**REQUEST**

Current Zoning: I-2 (general industrial)  
Proposed Zoning: MUDD-O (mixed use development, optional) with five-year vested rights

Approximately 3.81 acres located on the west side of Thrift Road and the south side of Berryhill Road.  
(Council District 3 - Mayfield)

The petition proposes to renovate two existing buildings in order to allow a mix of uses as permitted in MUDD (mixed use development).

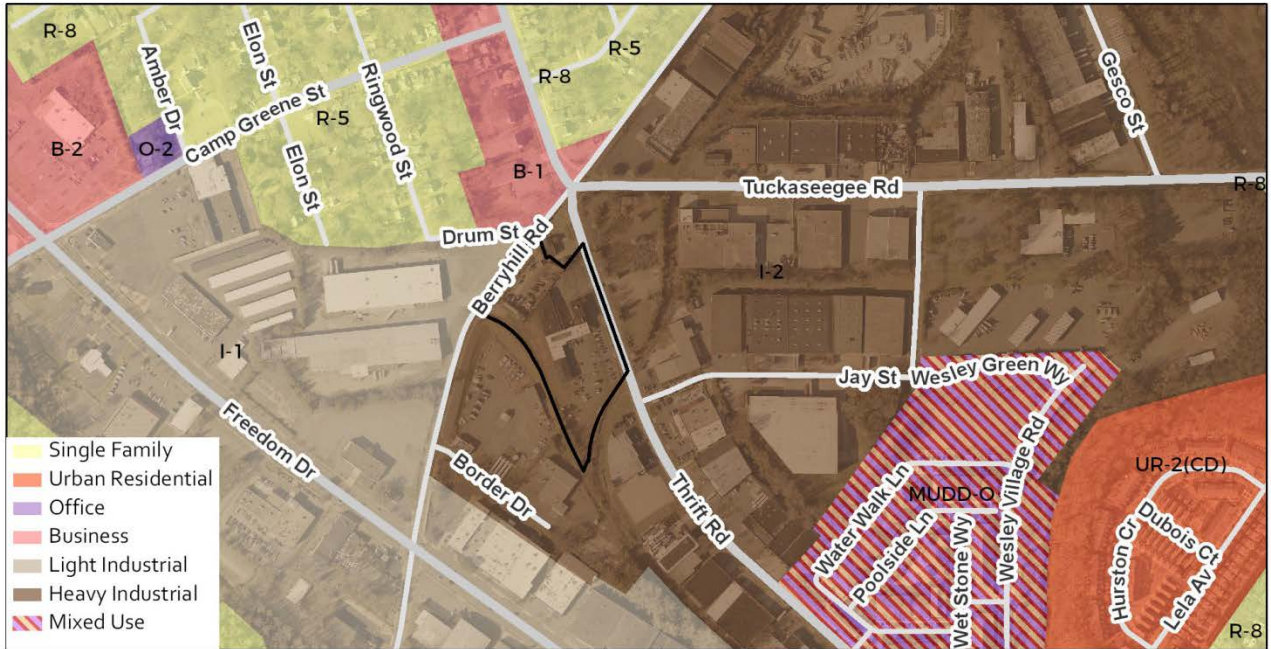
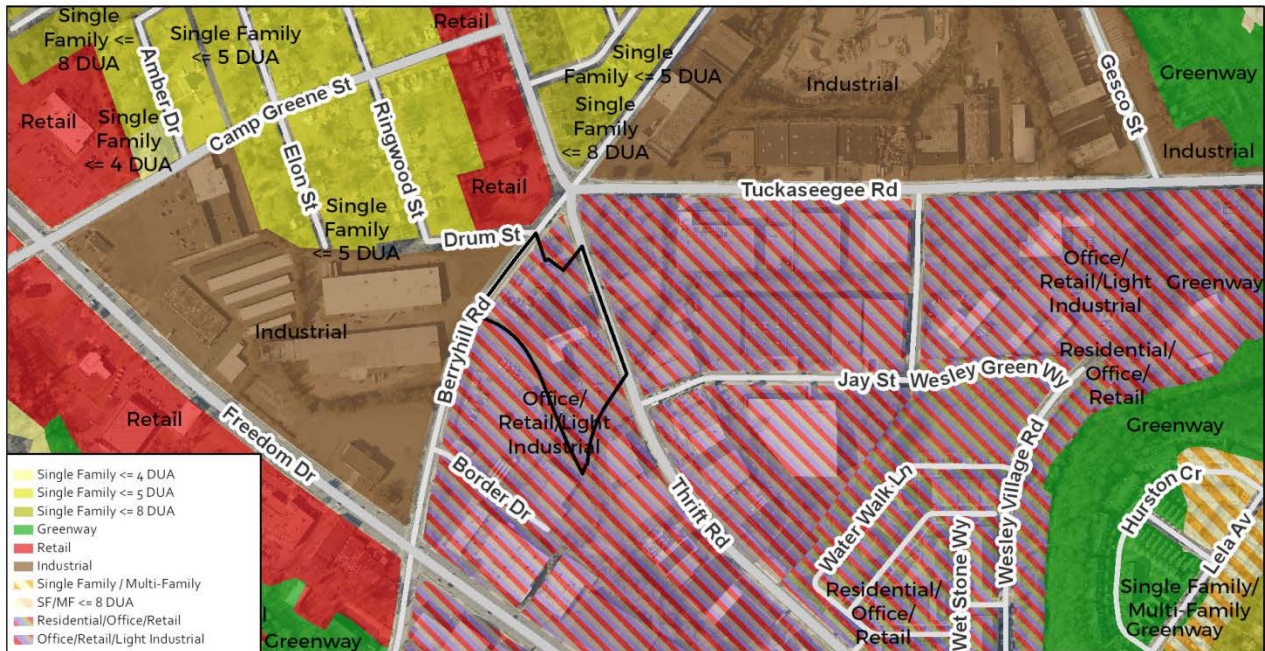
1. Revise Note 19 as follows: The petitioner shall comply with the Charlotte City Council approved and adopted Post Construction Stormwater Ordinance.

2. Per General Provisions Note 1, clarify Development Summary to note proposed addition and total building square footage.
3. Per General Provisions Note 1, show area of proposed 12,000 square foot addition. Please note site must be able to accommodate parking for total building square footage.
4. Per General Provisions Note 1, petitioner needs to modify Permitted Uses Note 7 to acknowledge/include 12,000 square foot addition.
5. Clarify Note 6 regarding where fence will be located as it may not be in the MUDD setback.
6. Remove "...will be allowed in the existing buildings" from Note 7.
